# Access Compliance Report

## Public Rights-of-Way

### (Curb Ramps)

Intersection ID: 9317	Main Street: JUDSON_AV	Cross Street: W_TRADE_ST	Location: W
ADA ID: 0E06AB826F62	Ramp Type: Perp	Initial Pass/Fail: Fail	Overall Compliance: No
Severity Score: 8.75			
Codes/Mitigation Info/Possible Solution		Field Measurements/Component Compliance

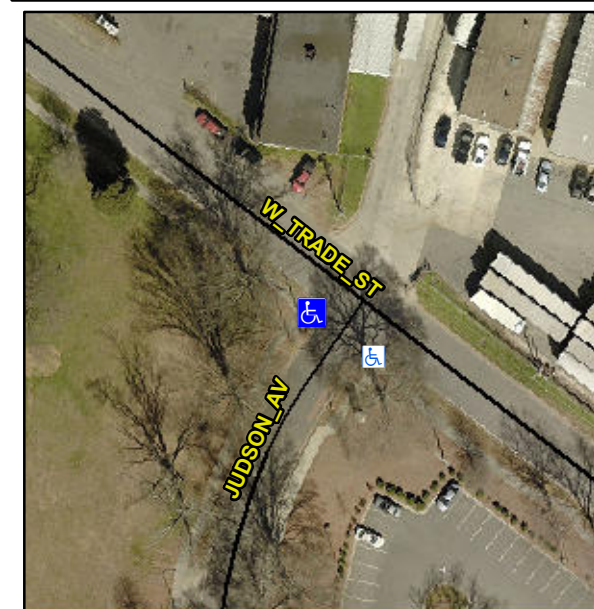
**Remove & Replace Entire Ramp.**

**R304.5.1**

Compliance	Description	Data	Compliance	Description	Data
N/A	Ramp Length (in)	116.0	Yes	Ramp Slope (%)	5.0
No	Ramp Width (in)	47.5	Yes	Ramp XSlope (%)	1.3
N/A	Flare Type LT	N/A	N/A	Flare Type RT	N/A
N/A	Flare Slope LT (%)	N/A	N/A	Flare Slope RT (%)	N/A
N/A	Flare Traversable LT?	N/A	N/A	Flare Traversable RT?	N/A
N/A	Landing Length (in)	N/A	N/A	DWS Provided?	N/A
N/A	Landing Width (in)	N/A	N/A	DWS Contrast?	N/A
N/A	Landing Slope (%)	N/A	N/A	DWS Length (in)	N/A
N/A	Landing X Slope (%)	N/A	N/A	DWS Full Width?	N/A
N/A	Landing Curb? (Y/N)	N/A	N/A	DWS Offset (in)	N/A
N/A	Shared Landing?	N/A			
N/A	Gutter Ponding?	N/A	N/A	Gutter Slope (%)	N/A
N/A	Gutter Lip Ht (in)	0.5	N/A	Gutter X Slope (%)	N/A
N/A	Painted X Walk1?	No	N/A	Painted X Walk2?	N/A
	X Walk 1 Direction	To SE		X Walk 2 Direction	N/A
N/A	X Walk 1 Width (in)	N/A	N/A	X Walk 2 Width (in)	N/A
	X Walk 1 Slope (%)	0.7		X Walk 2 Slope (%)	N/A
	X Walk 1 X Slope (%)	2.8		X Walk 2 X Slope (%)	N/A
